**MONTICELLO NUCLEAR GENERATING PLANT**  
Docket No. 50-263 License No. DPR-22

License Amendment Request  
Revised Pressure and Temperature Curves

License Amendment Request  
Revised Pressure and Temperature Curves

Figure 3.6.2 Minimum Temperature vs. Pressure for Pressure Tests

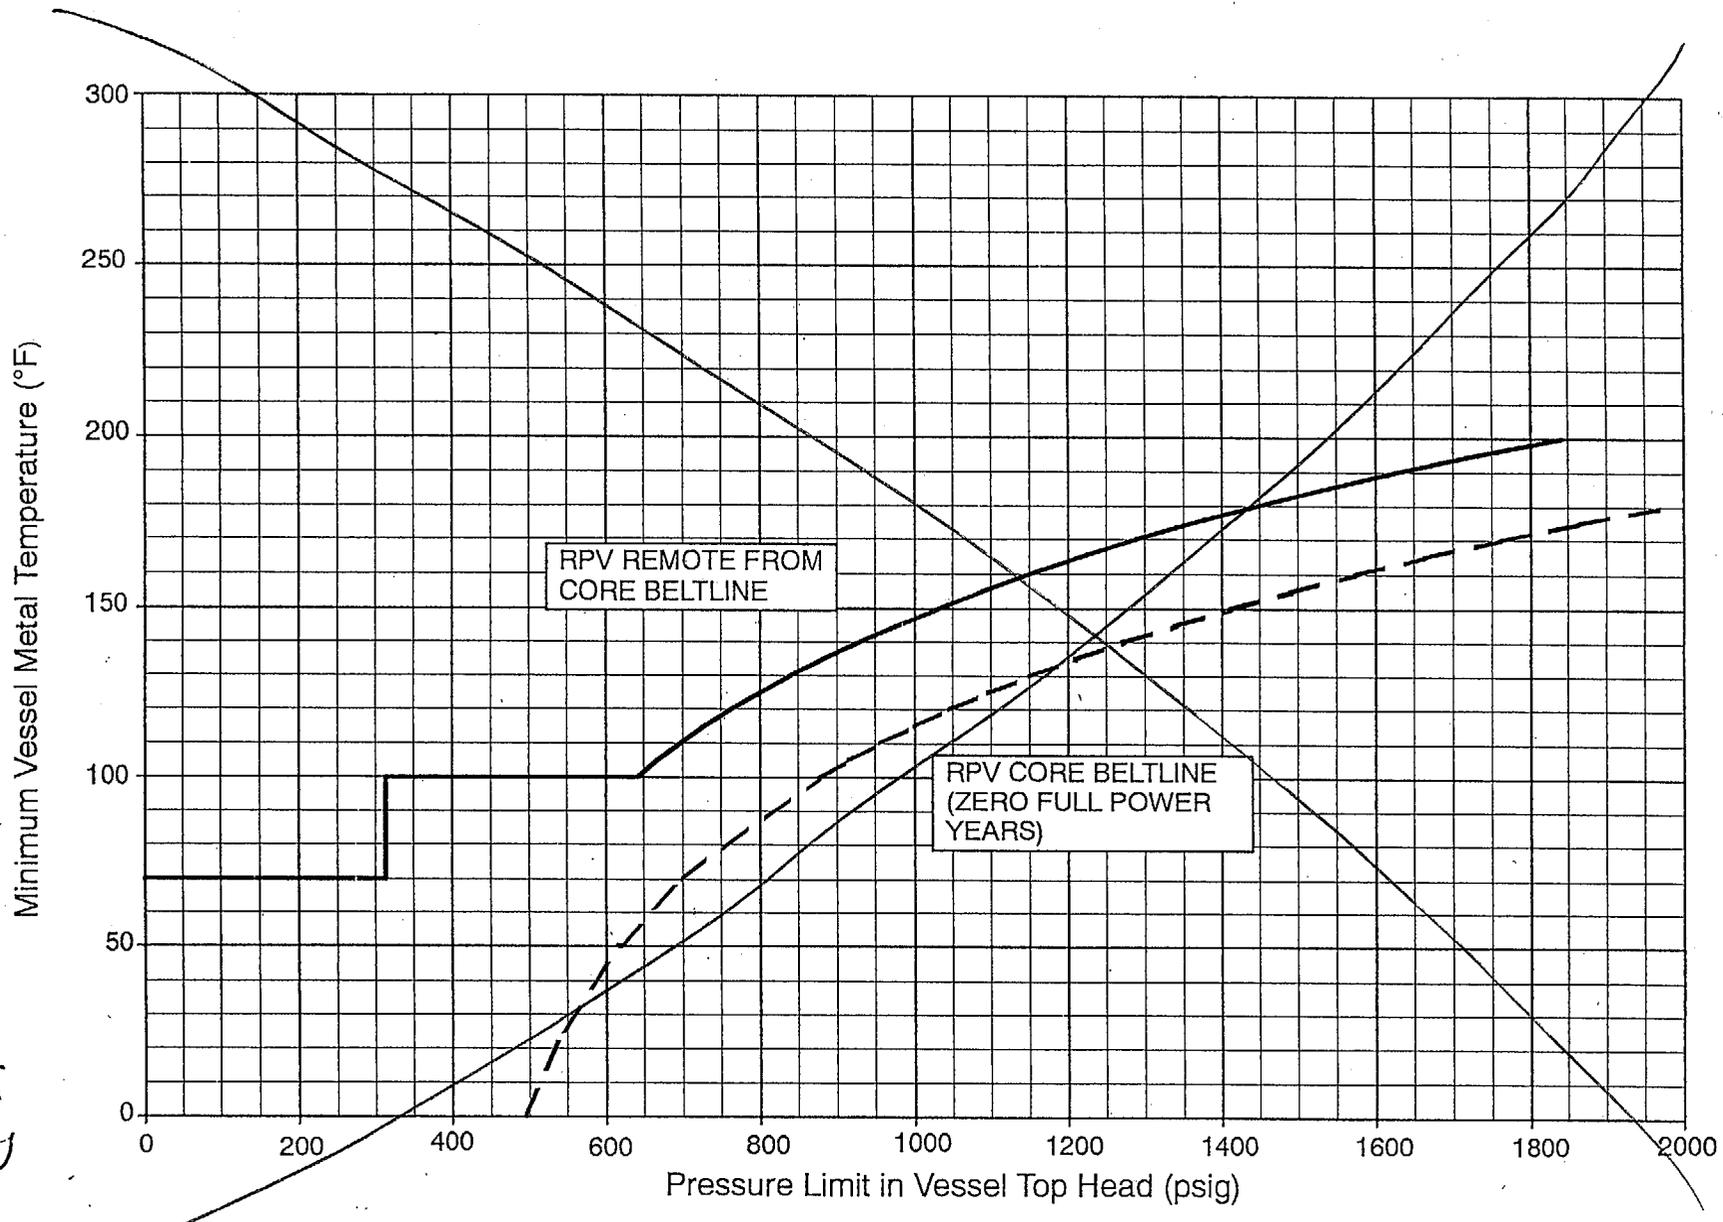
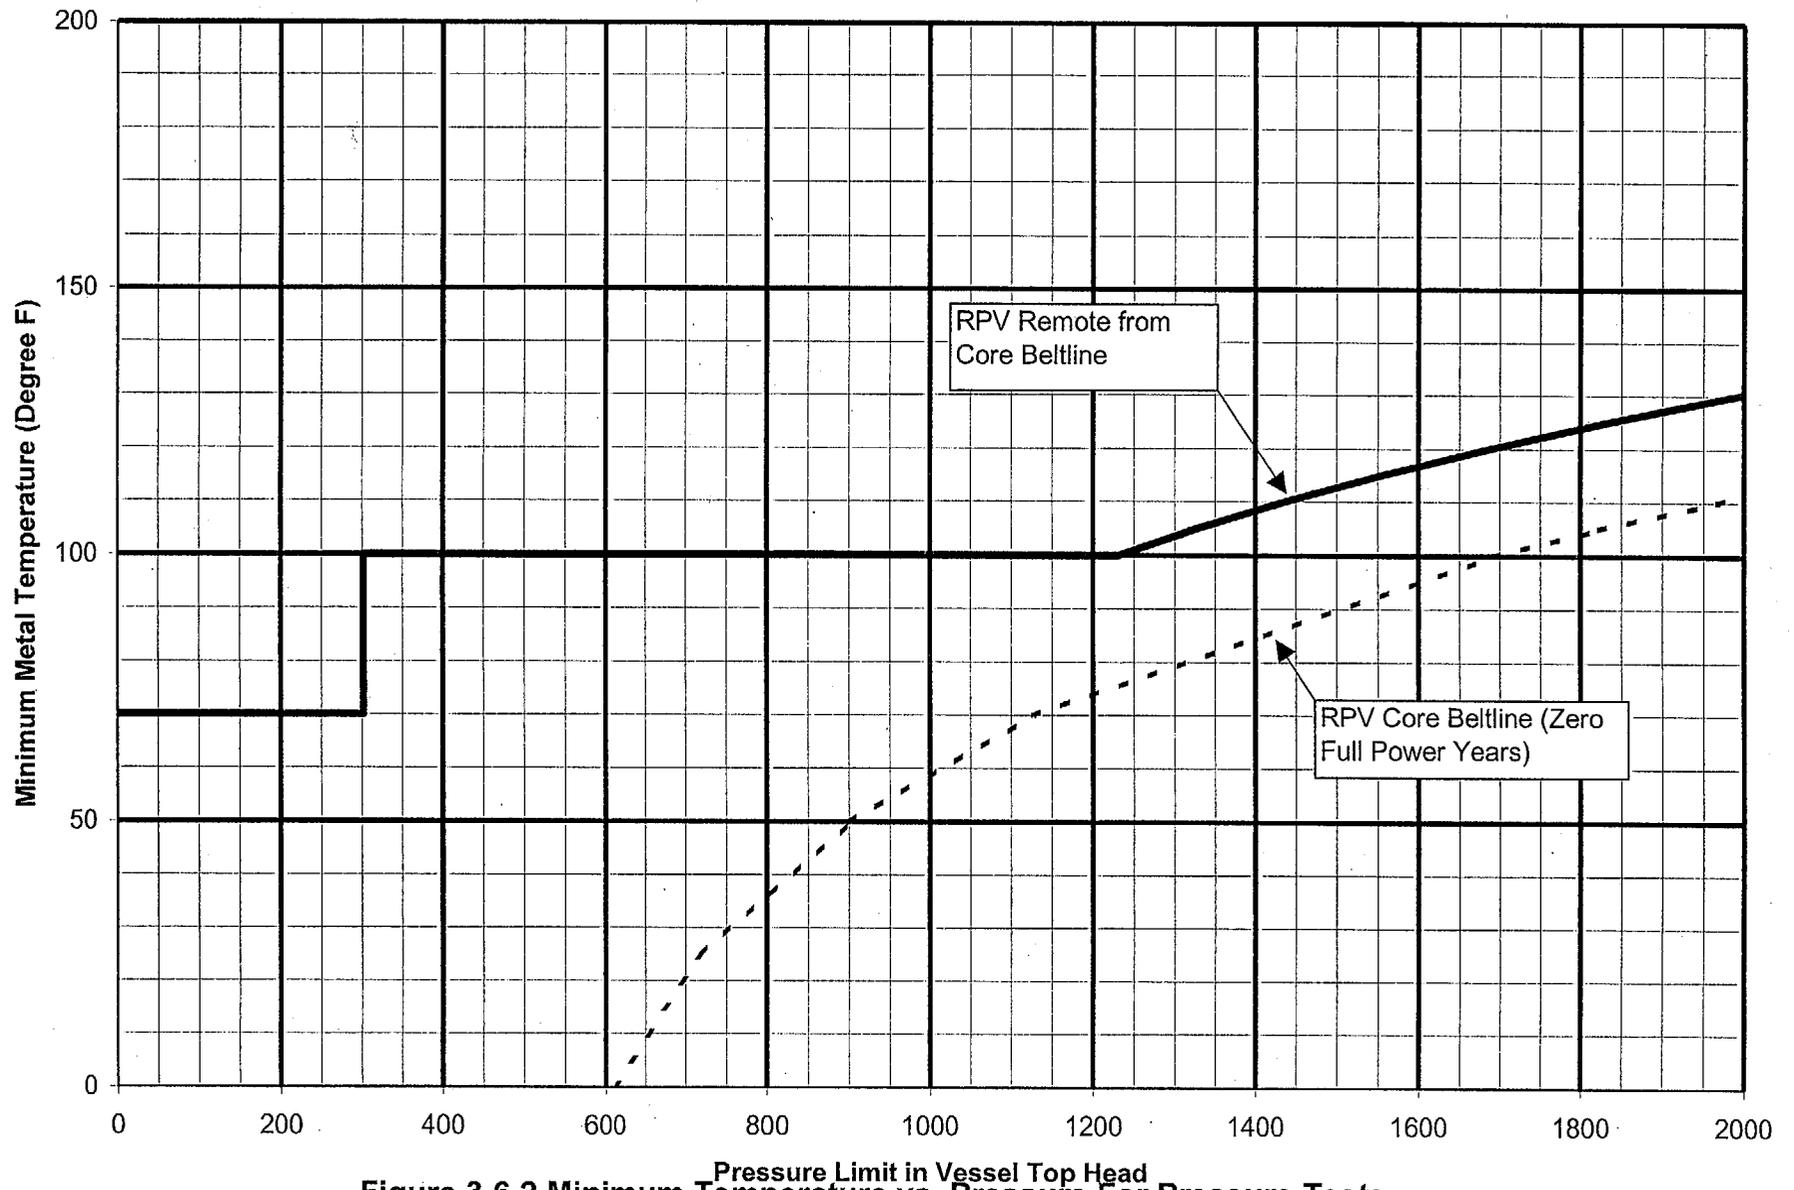
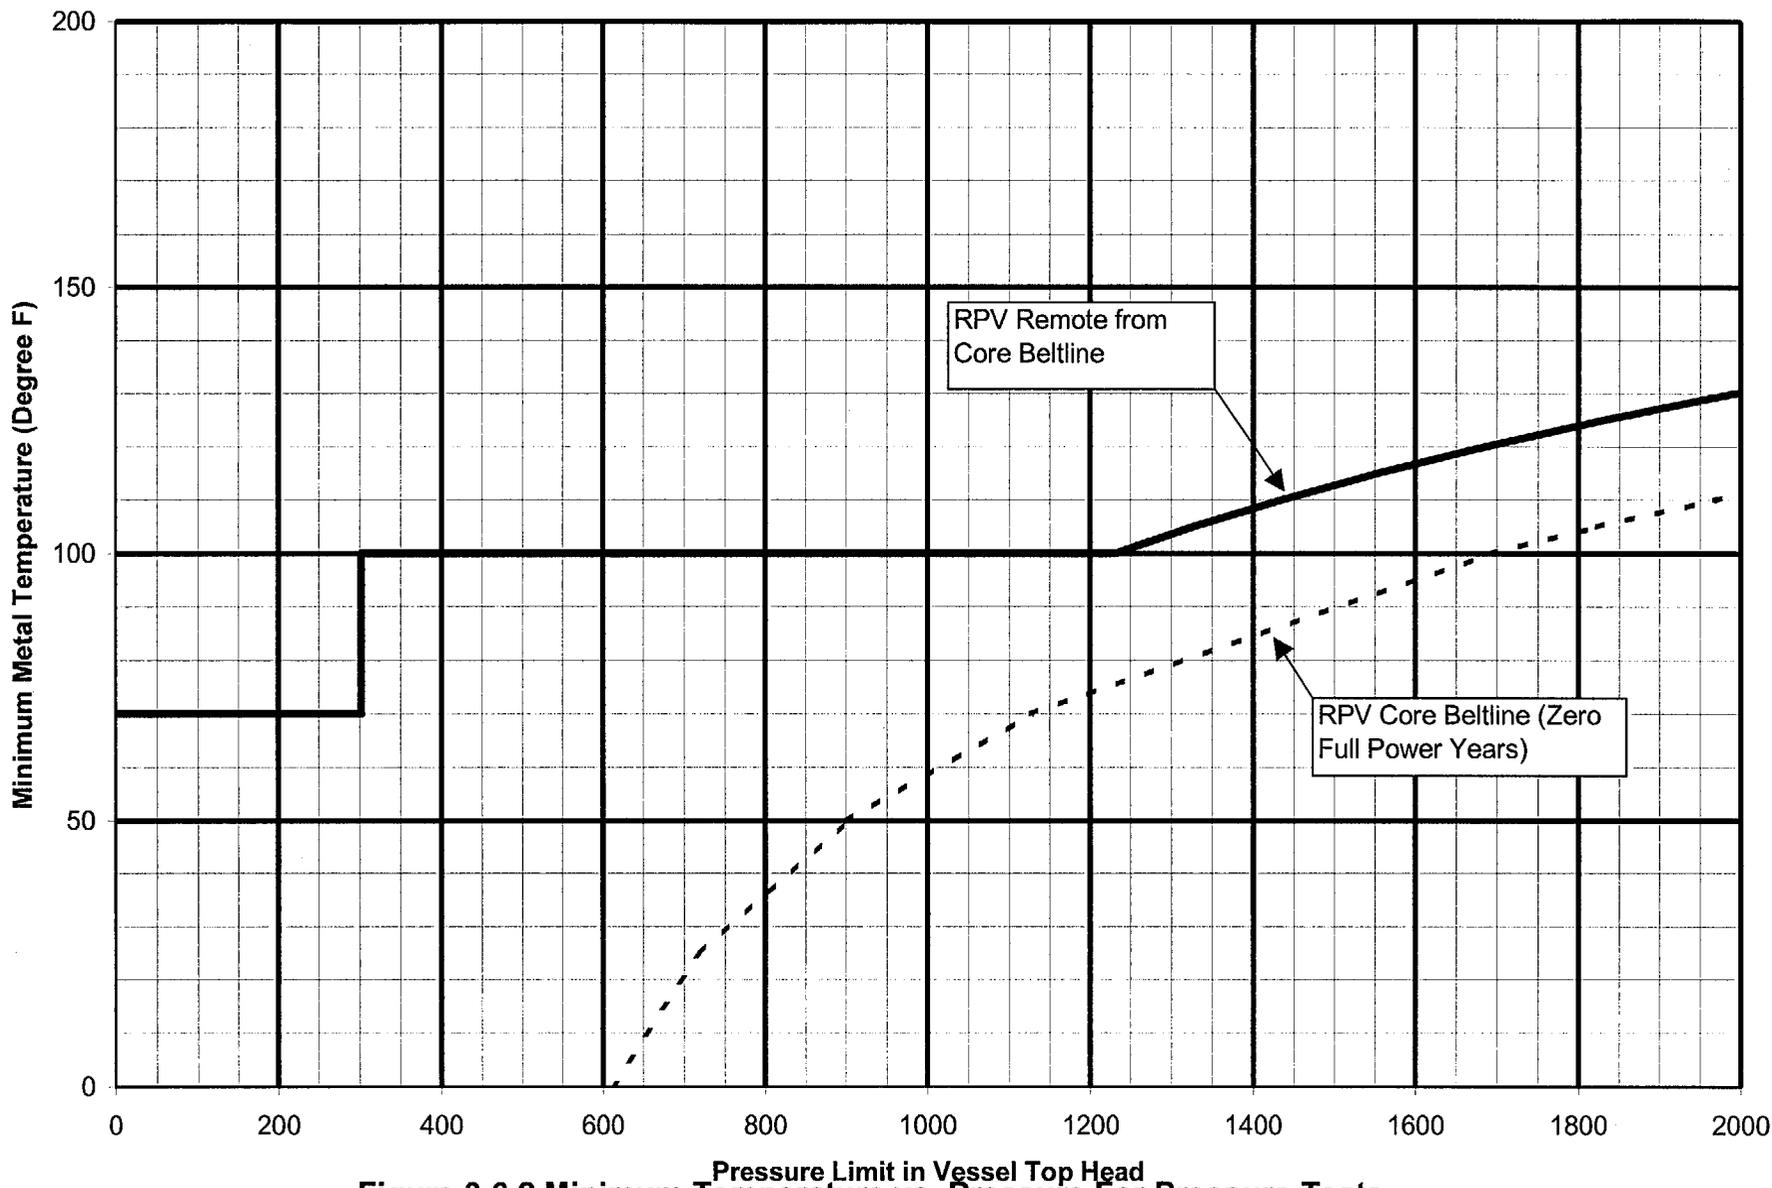
NMC proposes to revise the Monticello TS requirements for reactor pressure vessel (RPV) P/T limit curves. Changes are proposed to Monticello TS Figures 3.6.2, 3.6.3 and 3.6.4 which show the P/T limit curves for inservice leakage and hydrostatic testing, non-nuclear heatup and cooldown, and criticality. No changes to the Limiting Conditions for Operation or any Surveillance Requirements of Technical Specification 3.6.B are proposed.

INSERT ATTACHED
